ADDENDUM No. 4

PROJECT NAME: Culebra Bulky Waste Collection Center (Project No. 55-000025)

DATE: December 10, 2013

CULEBRA BULKY WASTE
U1

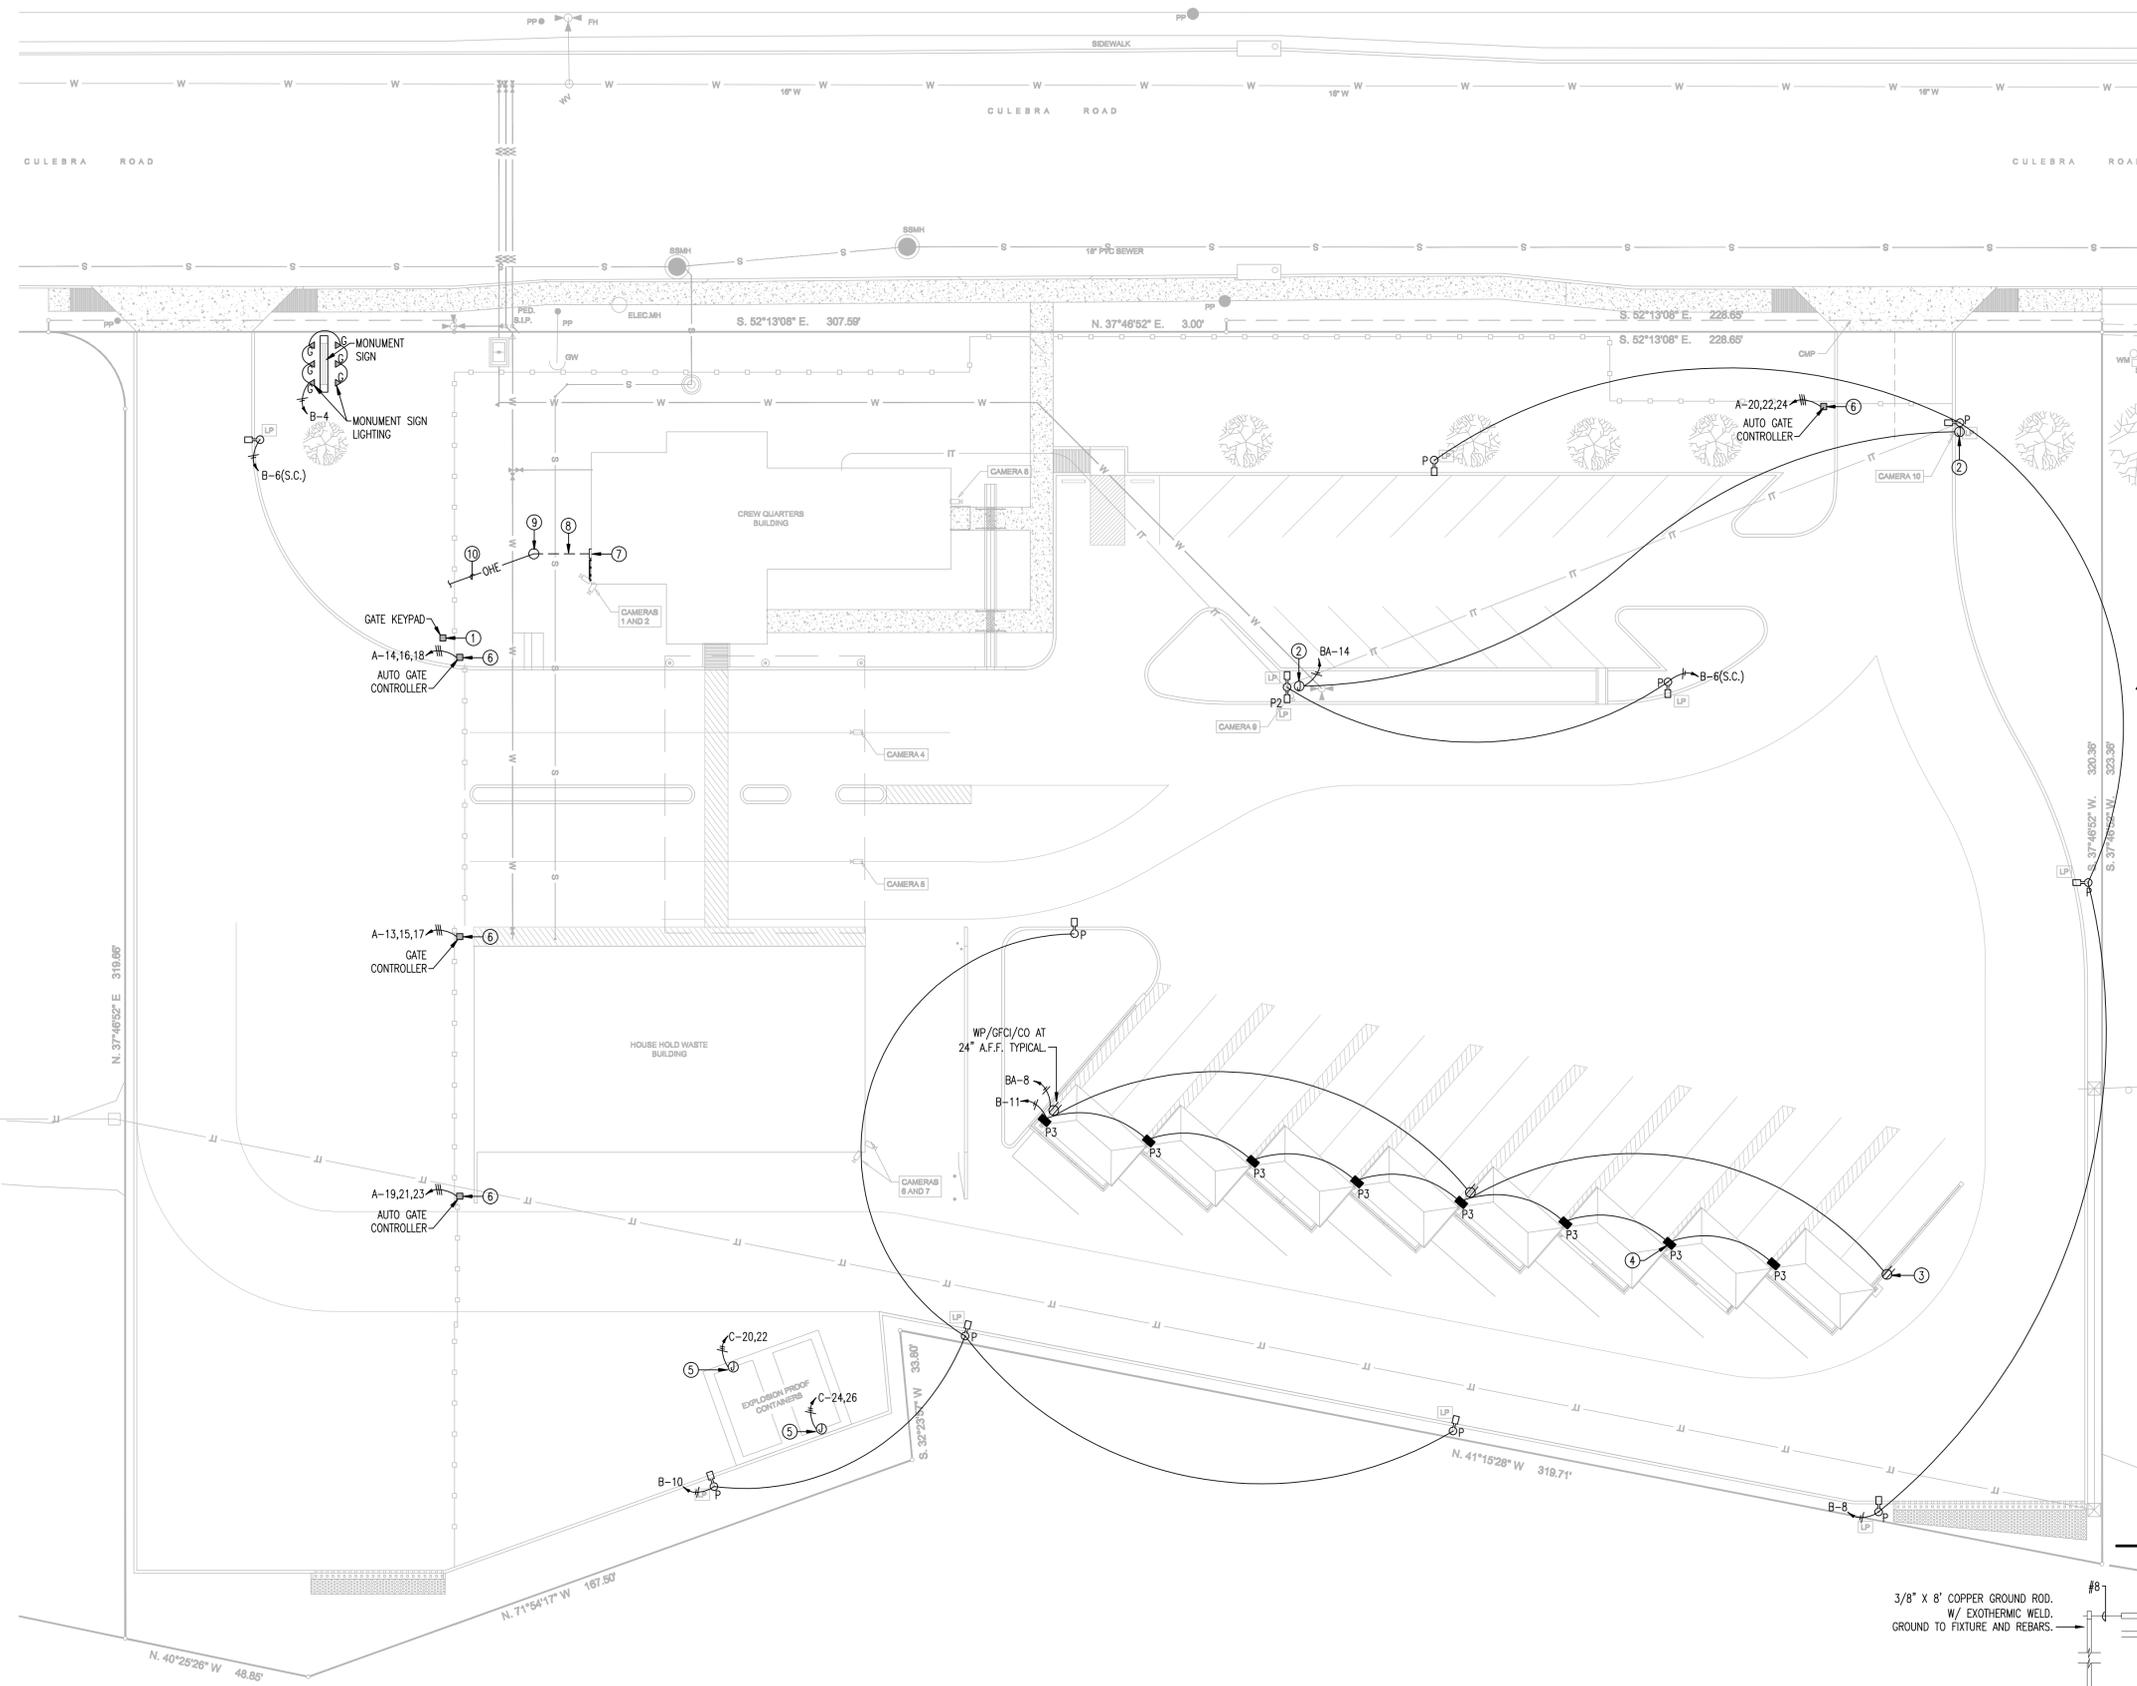
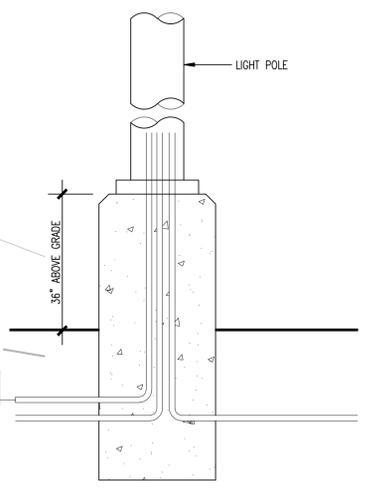
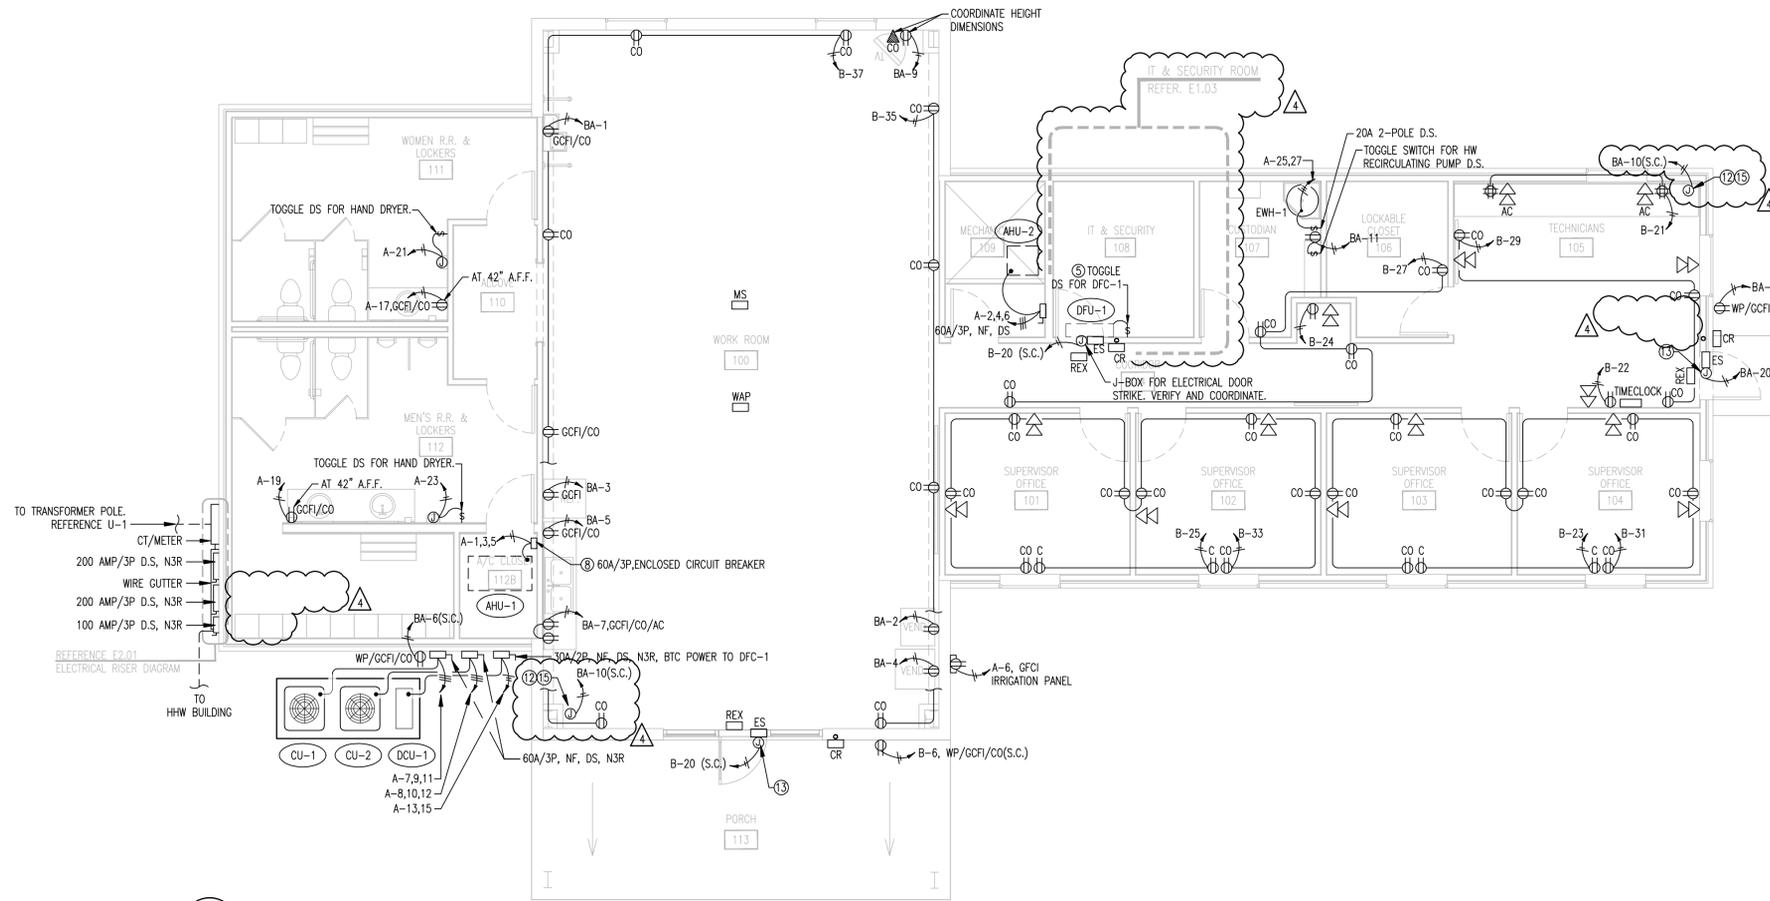
7. **The detail on Addendum 2 sheet U-1 for the pole lights does not show the junction boxes to be inside the pole light concrete base. The new Sheet T-5 still shows the boxes. There is no information about these boxes. What manufacturer and model number for these boxes will be required? If these boxes are not required, will the 1” rigid conduit shown on the detail on sheet U1 still be required? If this conduit is installed without junction boxes in the concrete bases, a lift will be required to pull or replace the cabling for the cameras.**

8. **On sheet U-1, keyed note #2 and in the pole light detail show junction boxes in the concrete pole light base for communication and CCTV power. Keyed note #2 says to coordinate with ArtCom about the boxes. There is no information about these concrete pole light bases boxes on the IT plans. What manufacturer and model number is required for the junction boxes?**

Answer: Sheet U-1 has been revised to address some of these questions. Please see note 2 concerning the power supply to the security cameras. Please see note 3 concerning mounting locations for the convenient outlets by the canopy drop-off areas. Neglect the notation concerning the 1” rigid conduit on sheet U-1. The light pole base detail indicates power conduit feed and grounding is required at each of the light poles. Also see the revised information technology sheets (“T” drawings for additional information).

- POWER FOR SECURITY CAMERAS MOUNTED ON LIGHT POLE (2 LOCATIONS). RUN CONDUIT AND TERMINATE IN J-BOX PROVIDED PER IT DRAWINGS. LOCATE AND MOUNT A GFCI DUPLEX RECEPTACLE ON TOP LEFT HAND OR RIGHT HAND SIDE OF THE J-BOX.

M2.04 EXHAUST FAN AND ROOF CAP DETAIL
SCALE: NOT TO SCALE

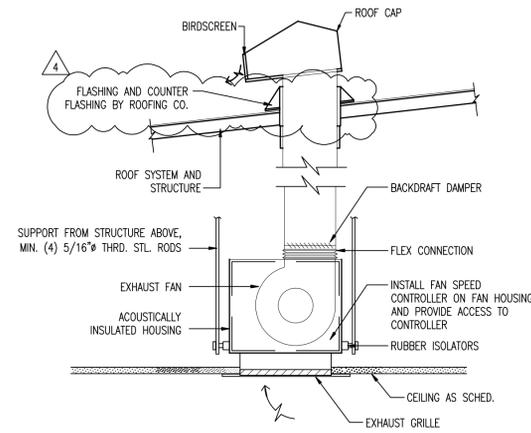
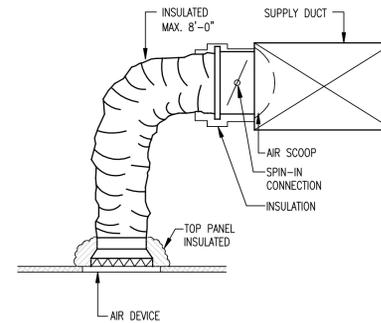
- U-1 Revised drawing dated 12-06-2013. Revisions include, but not limited to, revised notes.
- E1 Revised drawing dated 12-06-2013. Revisions include, but not limited to, added camera mounting details, revised power to IT and security equipment, and revised notes.
- E2 Revised drawing dated 12-06-2013. See modifications to the power plan.
- E3 Revised drawing dated 12-06-2013. Revisions include, but not limited to, revised power to IT and security equipment, and revised notes.
- M2 Revised drawing dated 12-06-2013. Revisions include, but not limited to, revised exhaust fan and roof cap detail.

02/A9.00
ADD4

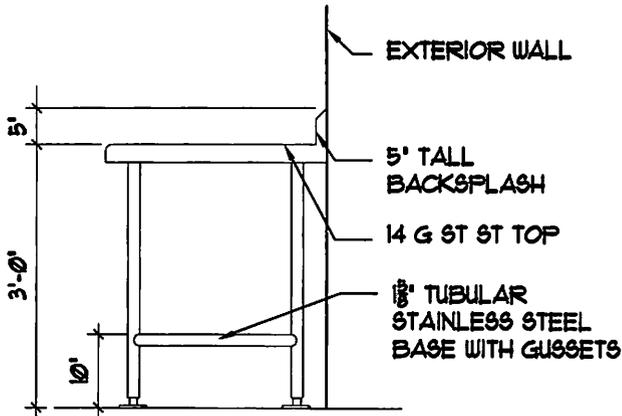
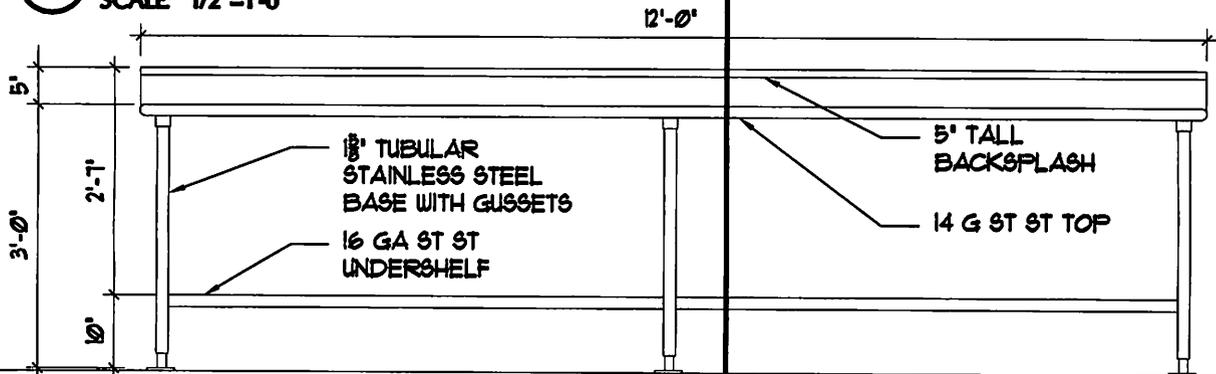
| 3) Sheet A9.00 | Elevation 15, Replace work countertop with attached countertop elevation, section and the following specification. Working top to be 14 gauge stainless steel. All seams and corners to be welded closed and finished. All edges to be turned down 1 1/2" at 90 degrees and hemmed. |
